An Independent Critique of Containment Loads Modeling Used in the Direct Containment Heating (DCH) Issue Resolution Effort*

David C. Williams

March 9, 1997

Figure 3-2. CONTAIN predictions versus experimental results for (a) ΔP and (b) scaled H_2 production with only processes considered in the DCH issue resolution models allowed to contribute to the DCH energy release.

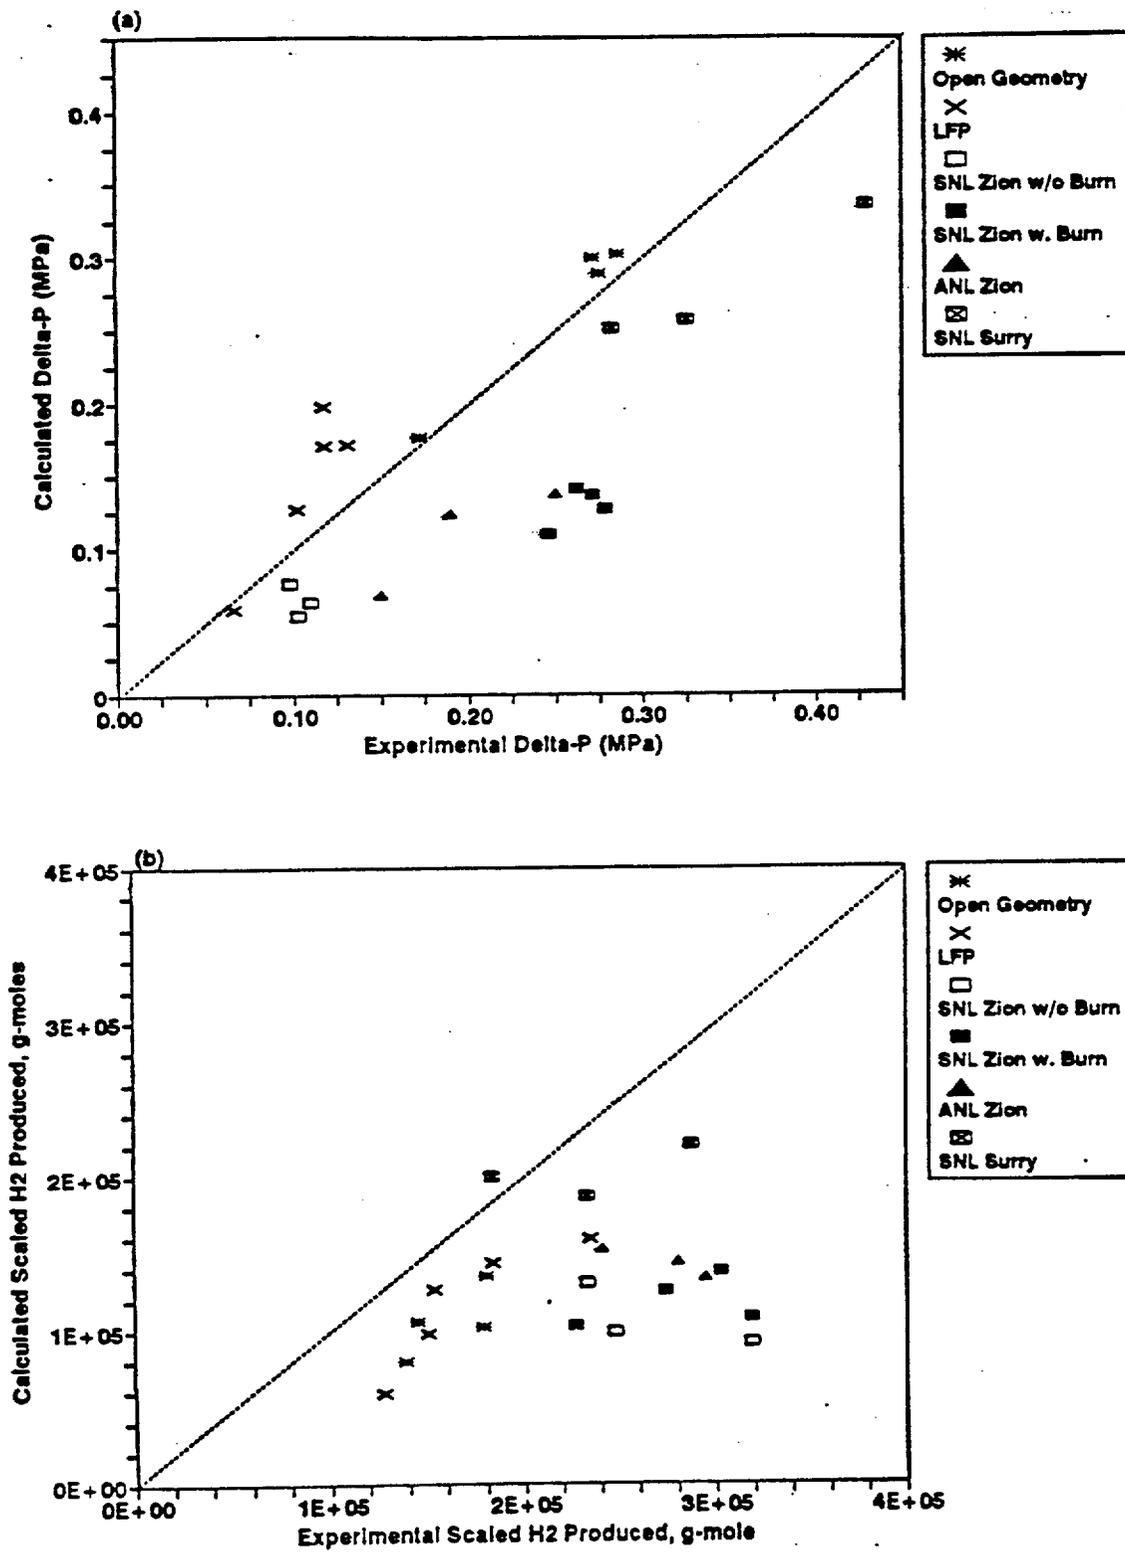
In Figure 3-2, results are presented for CONTAIN calculations in which the processes contributing to DCH are restricted to those considered in TCE (the match is only approximate; an exact simulation of the TCE model assumptions is not possible using CONTAIN). In particular, neither NAD interactions nor debris-water interactions are included. The mitigation processes neglected by TCE are still included, however. It is seen that many of the ΔP results, and almost all the hydrogen production results, are significantly underpredicted when the CONTAIN model is restricted in this way. By a considerable margin, the largest underpredictions are for the Zion-geometry IET experiments (square and triangular plot symbols). The underprediction in hydrogen production is at least a factor of two for these cases, and the underprediction of ΔP is also about a factor of two for those SNL/IET (Zion) experiments in which the hydrogen produced could burn (solid square plot symbols).

The principal reason for this underprediction is that, with the mitigation processes included, calculations restricted to the DCH processes considered by TCE do not transfer sufficient energy to the containment atmosphere to account for the observed containment pressurization, nor can these processes generate sufficient hydrogen to account for the reported hydrogen production. Extensive sensitivity studies are cited in SAND94-1174 that support the conclusion that uncertainties in the processes that are modeled in obtaining the results given in Figure 3-2 are not nearly large enough to explain the deficiency in the calculated ΔP and hydrogen production, at least in the case of the Zion IET experiments. Processes not modeled in either the Figure 3-2 CONTAIN calculations or in TCE must be contributing.

Figure 4-1. Predicted versus experimental ΔP results for (a) the two-cell equilibrium (TCE) model and (b) the total steam correlation (TSC).

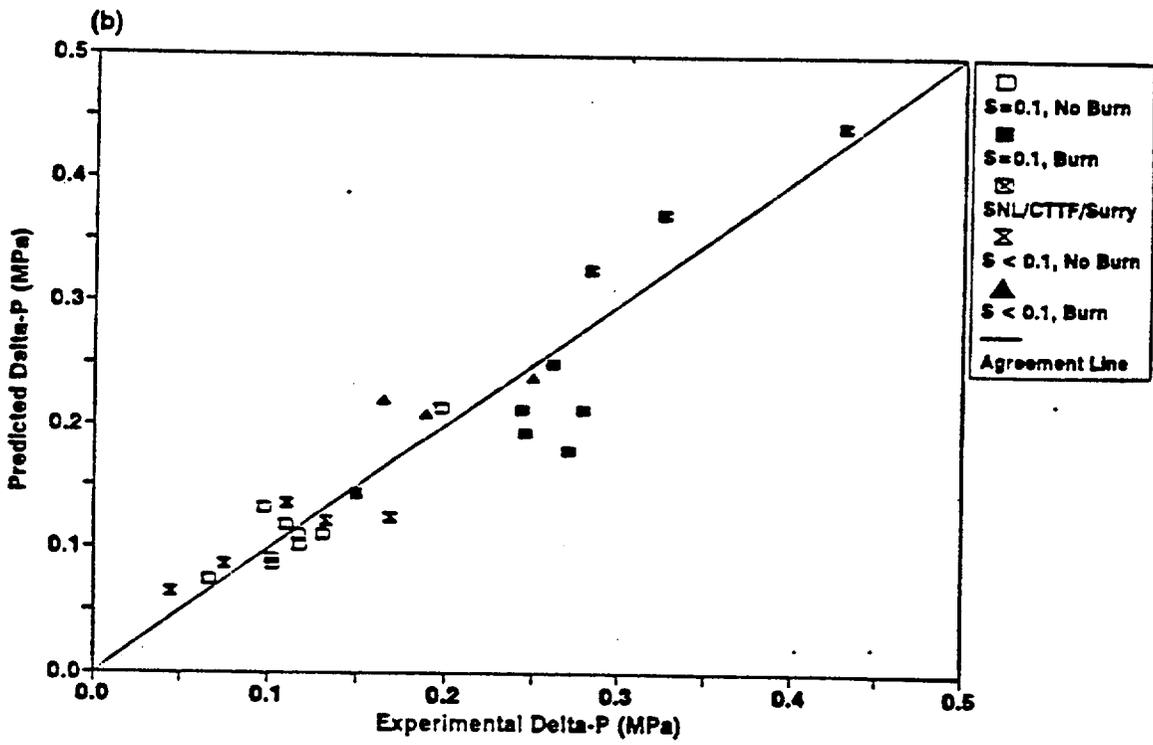
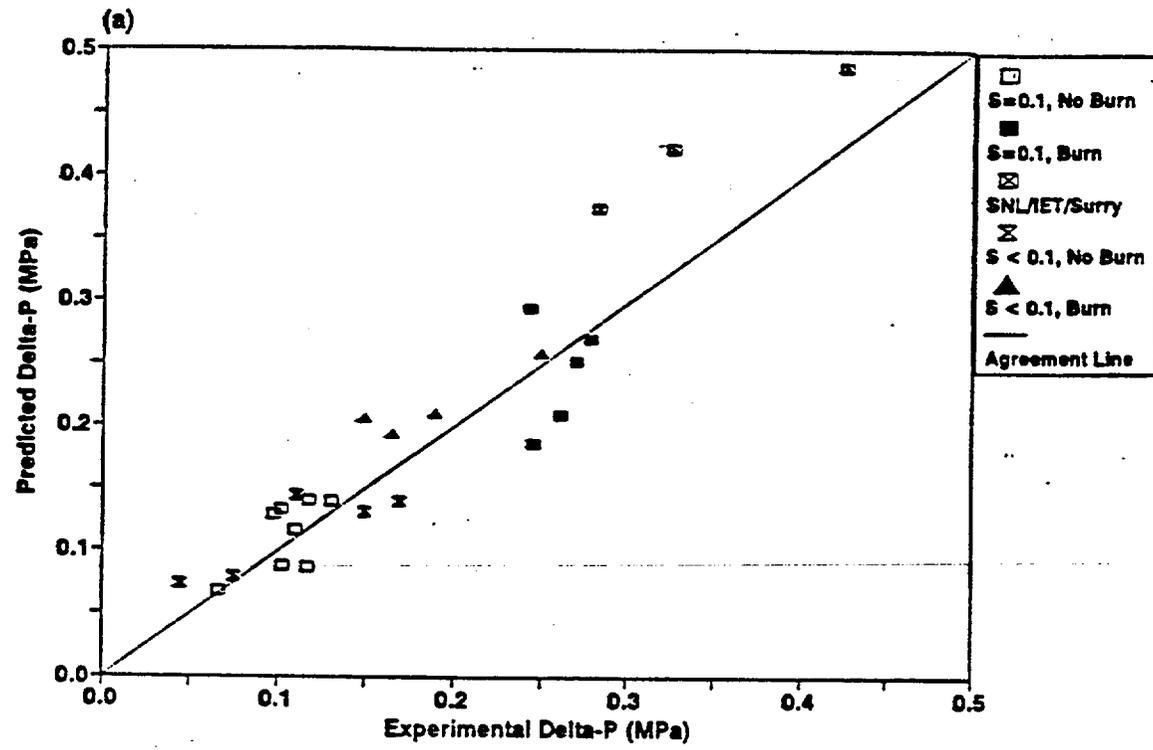
It is apparent from Figure 4-1a that, with some qualifications, TCE gives a reasonable correlation of the DCH ΔP data base; indeed, global agreement between the model and experiment is comparable to that obtained with CONTAIN in Figure 3-1a. However, this result is not as significant as one might suppose because it turns out that the DCH data base exhibits a relatively simple systematics that can be fit by DCH "models" that are demonstrably very inadequate. We can illustrate this point using what will be called the total steam correlation (TSC). This correlation is based upon the simple assumption that, in

In Figure 4-1b, ΔP values given by Eq. (4-1) are plotted against the experimental values for all DCH experiments that have been performed in which the containment was compartmentalized and steam was the driving gas. Data required for evaluating Eq. (4-1) were taken from the compilation of DCH experimental parameters and results given by Pilch et al. (1994a), and the experiments included are the same as those included for TCE in Figure 4-1a. It is evident that the ΔP values are strongly correlated by the accumulator steam supplies and hydrogen combustion behavior, with about 86% of the variance in the ΔP values being explained by these two factors (i.e., $R^2 = 0.86$). Furthermore, the ability of Eq. (4-1) to correlate the data is about as good as is the case for TCE in Figure 4-1a, for which $R^2 = 0.88$.

illustrate how a demonstrably *inadequate* model can fit the ΔP data reasonably well. TSC cannot possibly provide an adequate model for predicting DCH loads in general: it includes no dependence upon most of the potentially important DCH parameters such as melt characteristics (mass, composition, temperature), vessel failure size, coherence ratio, fraction of debris dispersed from the cavity, presence or absence of pre-existing hydrogen in the containment, etc. The fact that TSC correlates the ΔP data as well as does TCE means that one cannot claim to have validated the dependencies of the TCE model upon these parameters simply by presenting plots such as Figure 4-1a. However, this type of plot is the only validation for TCE that is offered in the entire issue resolution effort. For example, there are no attempts to identify cases in which a single parameter is varied and to determine whether TCE reproduces the observed variations in the experimental results.

Even as it is, TCE tends to overpredict the ANL/IET experiments with oxygen-bearing atmospheres and underpredict the corresponding SNL/IET (Zion) cases (see Figure 4-1a). With more consistent coherence ratios, this trend would be enhanced. Other cases in which using more consistent coherence ratios would likely worsen agreement with experiment are noted in Appendix B.

Figure 4-2. Predicted versus experimental scaled hydrogen production results for (a) the two-cell equilibrium (TCE) model and (b) the total steam correlation (TSC).

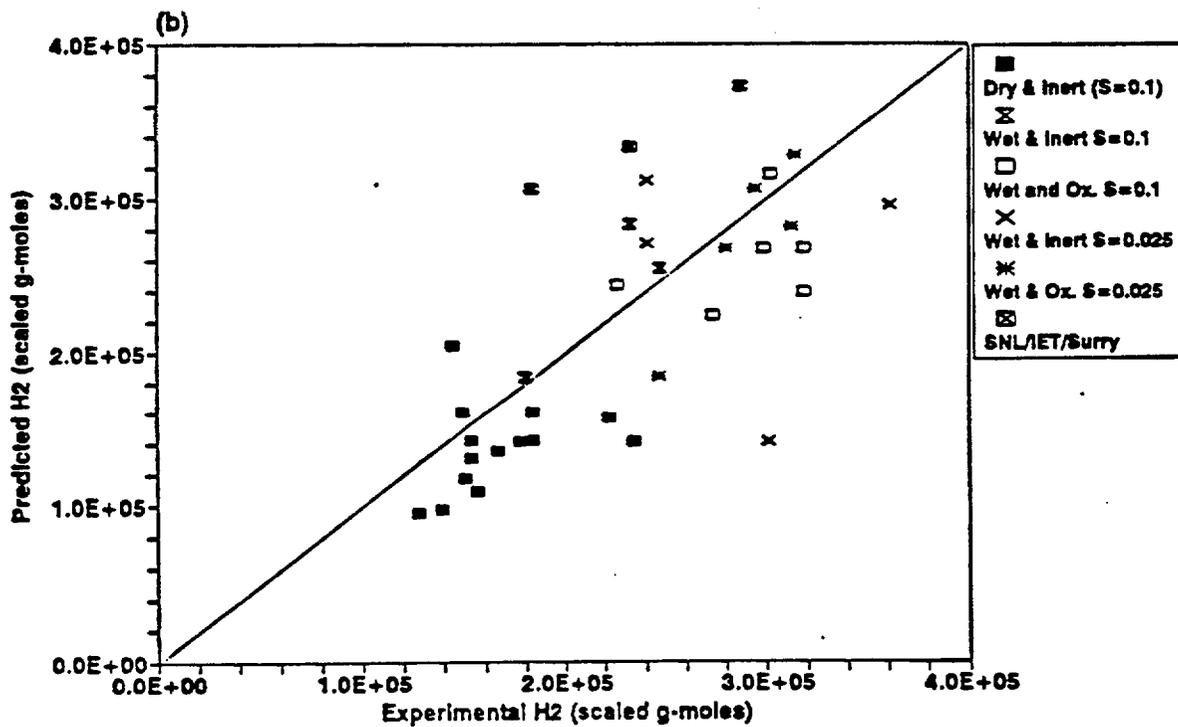
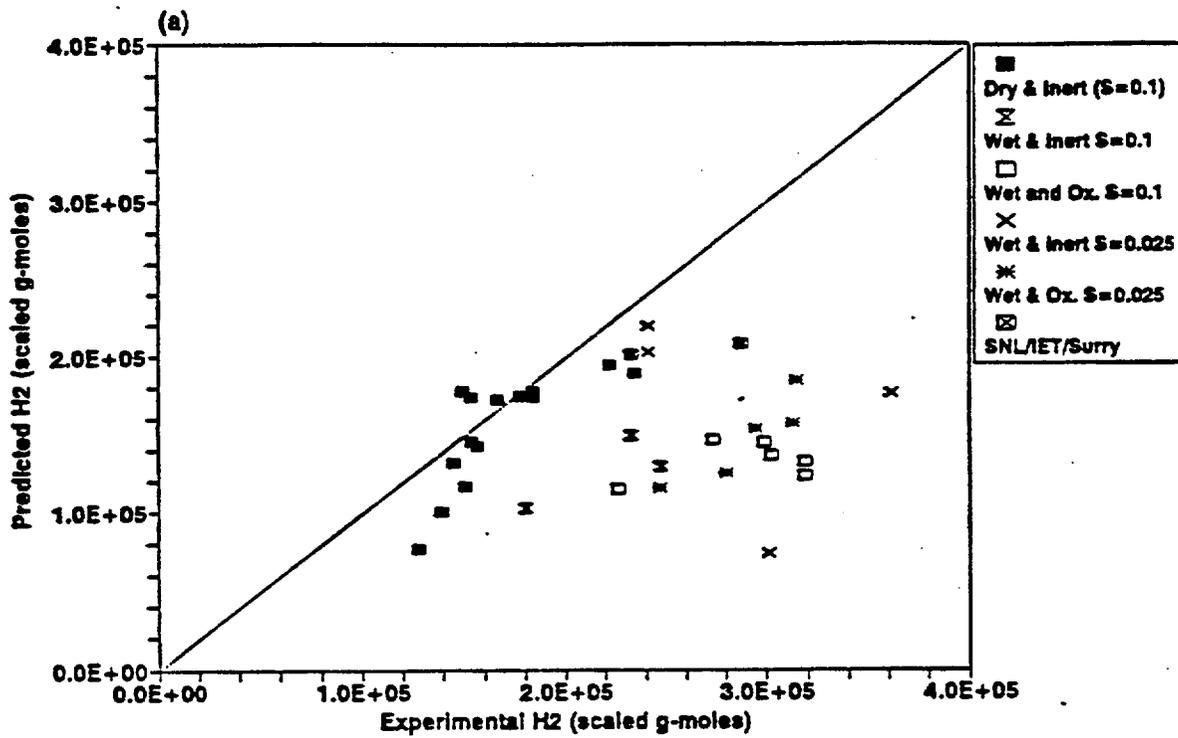
When the complete hydrogen production data base is considered, it is evident from the data plotted in Figure 4-2a that there is no statistically significant correlation at all between TCE model predictions for hydrogen production and the experimental results ($R^2 \approx 0.01$). These results may be contrasted with the CONTAIN predictions of hydrogen production, which reproduced the dominant experimental trends reasonably well (Figure 3-1b). Note also the contrast with respect to the ΔP results, for which TCE and CONTAIN demonstrate comparable abilities to reproduce the experimental data. Even the simplistic TSC reproduces the experimental trends for hydrogen production better than does TCE; although Figure 4-2b shows much scatter in the data, there is still a significant correlation ($R^2 \approx 0.5$).

Pilch et al. (1994a) acknowledge that TCE substantially underpredicts the hydrogen production in many of the experiments for which there was either water in the cavity or oxygen in the containment atmosphere, or both.* However, it is argued there that only the experiments with no water in the cavity (or elsewhere in the containment) *and* with inert atmosphere should be included in validating model predictions for hydrogen production on DCH time scales. Here, "DCH time scales" may be taken to be approximately the time required to complete the blowdown of the steam accumulator. This blowdown time was typically about equal to, or slightly greater than, the time at which the containment vessel pressure reached its maximum value.

The only cases accepted for TCE validation by Pilch et al. (1994a) are the "dry & inert" cases in Figure 4-2, and these cases do show an approximate correlation between TCE predictions and experimental results. Note that restricting validation to these cases limits the data base for model validation to experiments that have very nonprototypic atmospheric compositions. It also limits the validation base to experiments with relatively low driving pressure (accumulator pressures ≤ 4.6 MPa) and with nonprototypic containment geometries, because all the experiments with higher driving pressures and/or prototypic containment geometries (that is, the IET experiments) had either water in the cavity, oxygen in the containment atmosphere, or both.

Figure 5-2. Cavity pressurization histories for (a) the SNL/IET-6 experiment and (b) the ANL/IET-6 experiment.

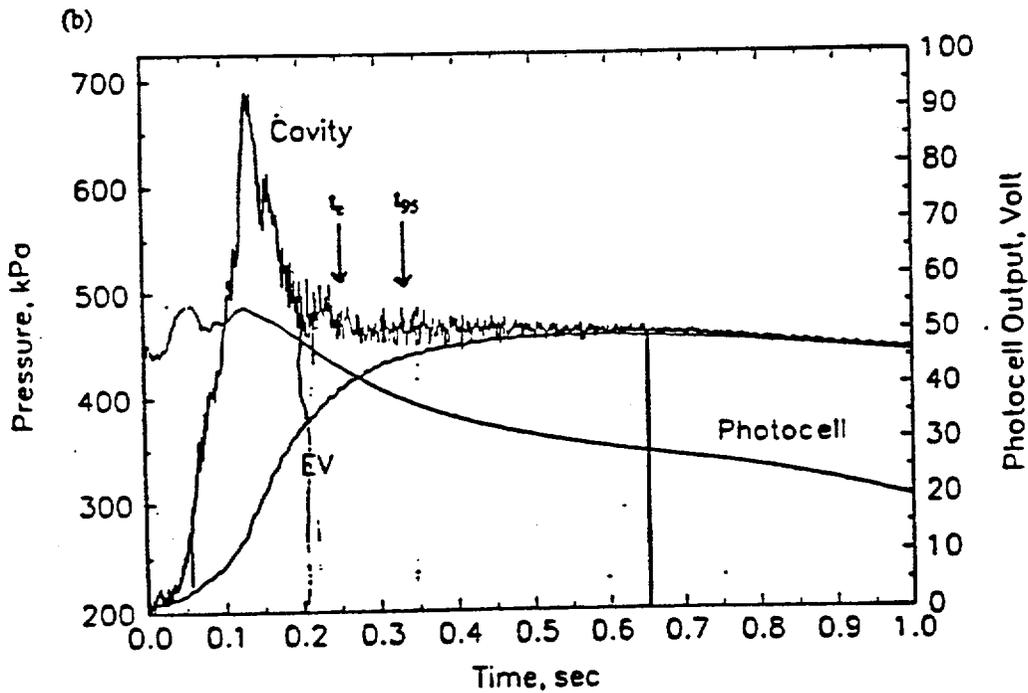
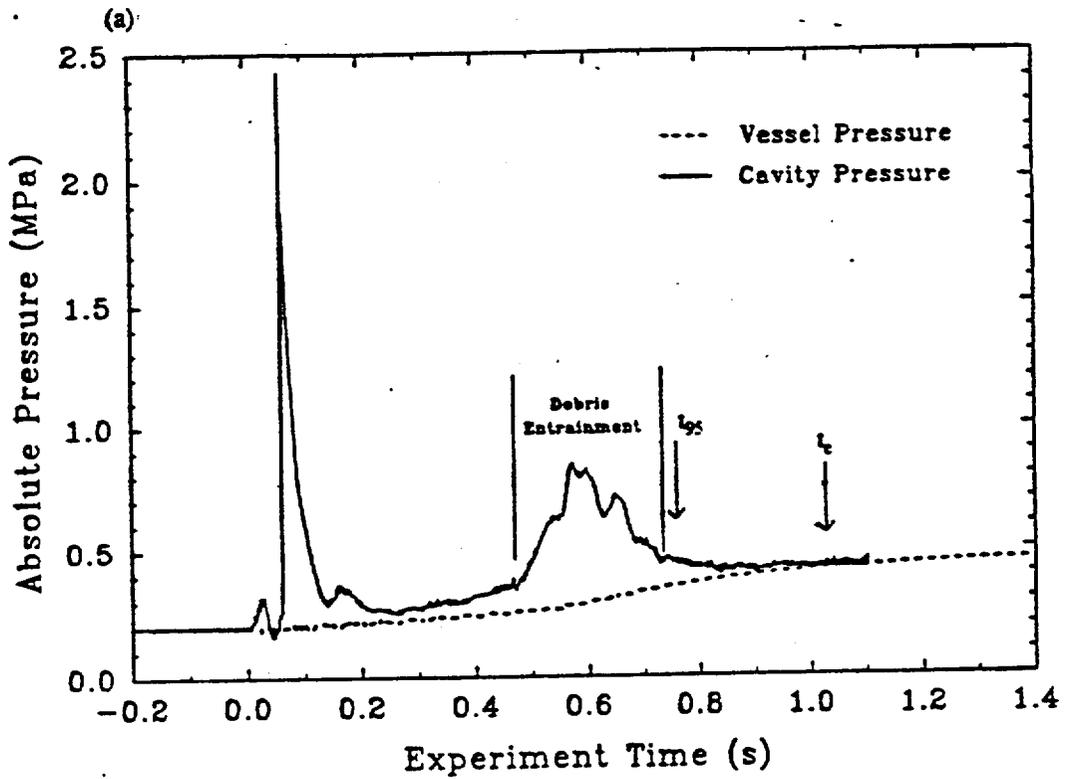
It is immediately apparent from the curves that the net cavity pressurization does not abruptly decline to zero at a well-defined time; instead, pressurization tails off gradually which poses a problem in defining the "correct" value of t_c for use in TCE. It is also clear that the shapes of the pressurization curves are quite different, which poses a problem in defining t_c in a manner that is consistent in going from one experiment to the next.

No specific methodology for determining the appropriate values of t_c from the cavity pressurization curves is discussed by Pilch et al. (1994a); apparently, this was done by simple inspection of the curves ("eyeballing"). The vertical arrows labeled t_c in Figure 5-2 indicate the values that were assumed by Pilch et al. (1994a) in calculating R_r for these two experiments. For SNL/IET-6, t_c was taken to be at the extreme right end of the tail in the cavity pressurization curve, while the pickoff point for ANL/IET-6 leaves much more of the tail outside the dispersal interval.

Figure 6-1. Hydrogen concentration and temperature rise scaling parameters, ϕ_{H_2} and ϕ_T , for the Westinghouse plants with dry containments considered in NUREG/CR-6338 (Pilch et al., 1996).

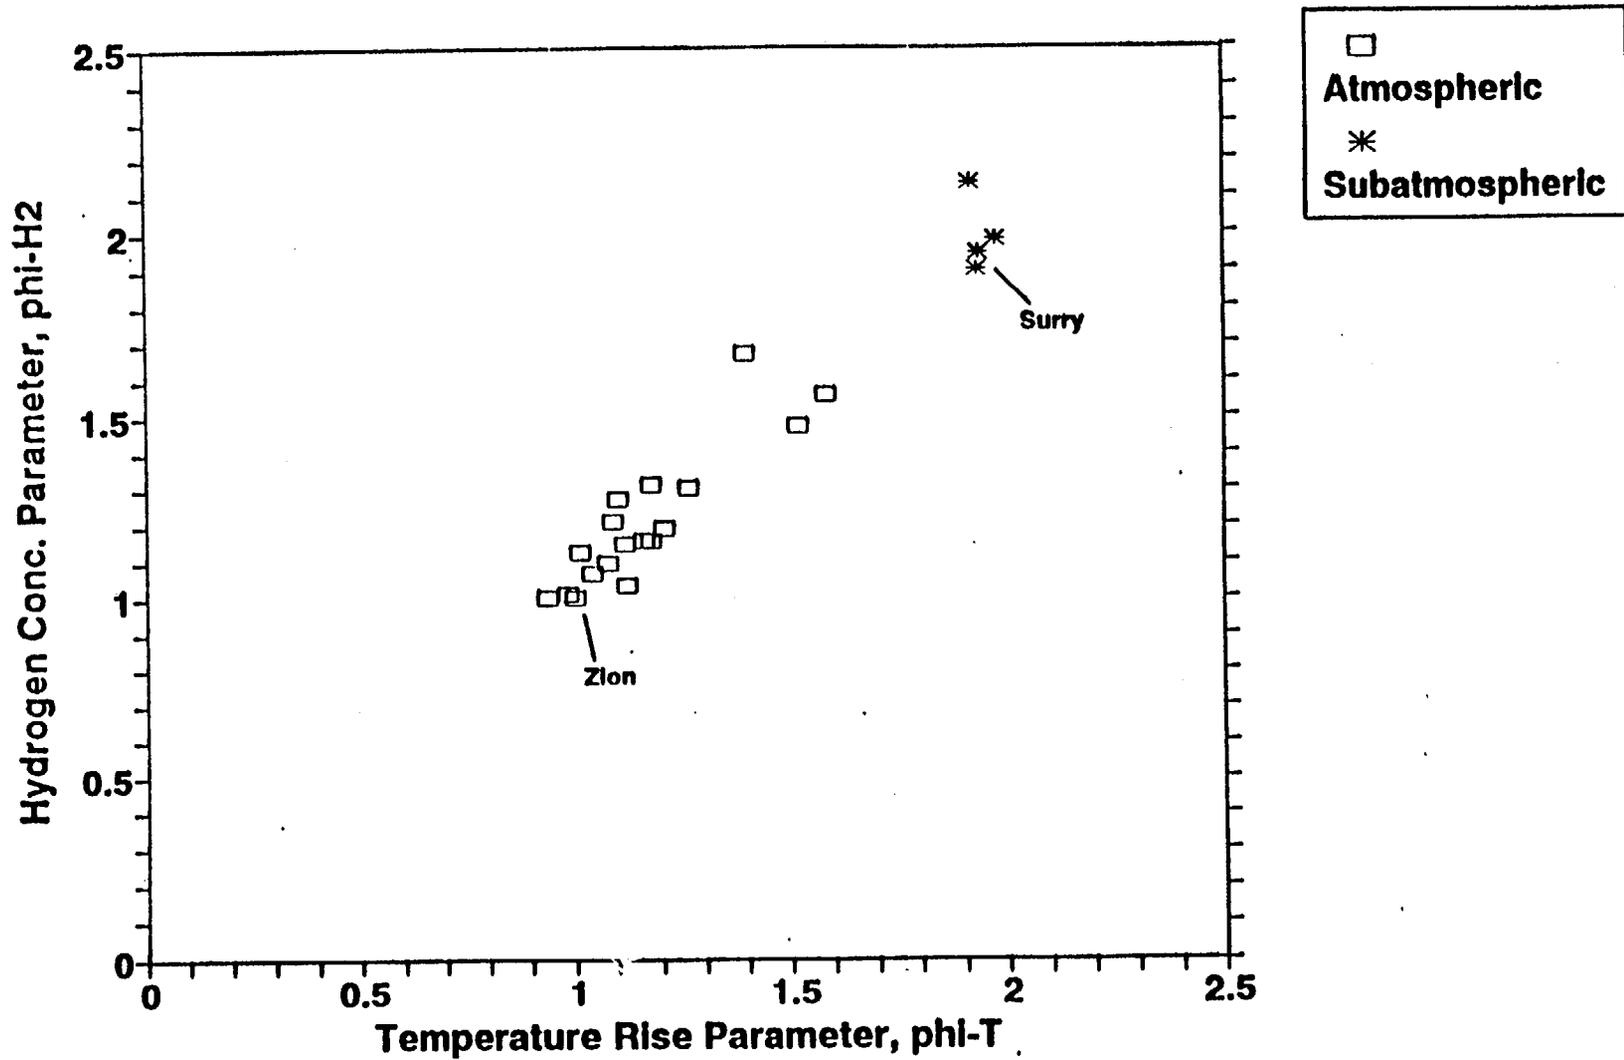
Figure 6-1 shows that Zion lies at the very bottom of the range for ϕ_{H_2} and close to the bottom of the range for ϕ_T . This means that, for most plants, a given fraction of in-vessel zirconium oxidation yields higher hydrogen concentrations than in Zion. Likewise, a given DCH efficiency results in greater temperature rises than in Zion. For the atmospheric plants, the values of ϕ_{H_2} and ϕ_T range up to about 60% greater than for Zion, and they are about a factor of two greater for the subatmospheric plants. For both parameters, larger values are expected to increase the tendency of pre-existing hydrogen to burn during a DCH event, and the experiments included somewhat nonconservative features even for Zion. Hence it seems clear that validating any DCH combustion model against the Zion experiments provides insufficient basis for using the model to extrapolate to the other plants analyzed unless uncertainties associated with these trends are assessed. No such assessment of these uncertainties has been carried out in the DCH issue resolution work, and the subject was never even mentioned.

Figure 6-1 shows that the Zion plant is among the least sensitive to hydrogen issues. Hence results cited for this single sensitivity case are not conclusive.
